Product Change Notification / KSRA-23RGWT440

CCB 4509 Initial Notice: Qualification of NSEB as a new assembly site for selected ATTINY2xx, ATTINY44x, ATTINY84x and AT42QT1040 device families available in 20L VQFN (3X3X0.85mm) package

CCB 4509
Pre and Post Change Summary
Lead Frame Comparison
PCN#: KSRA-23RGWT440

ASKR

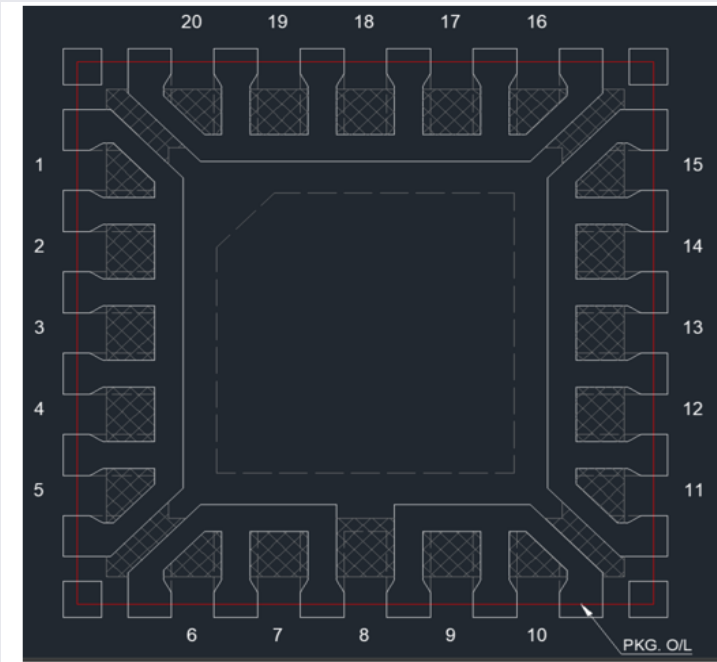
Lead frame lead-lock

No

NSEB

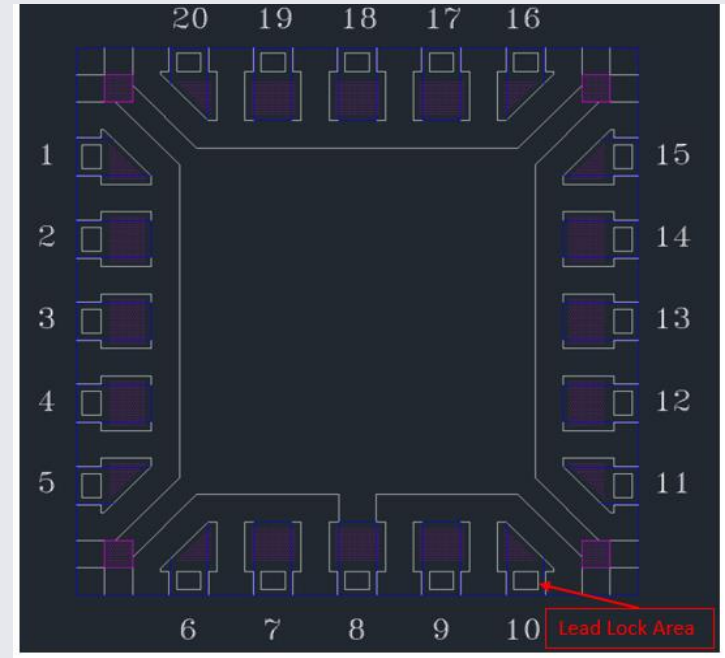
Lead frame lead-lock

Yes
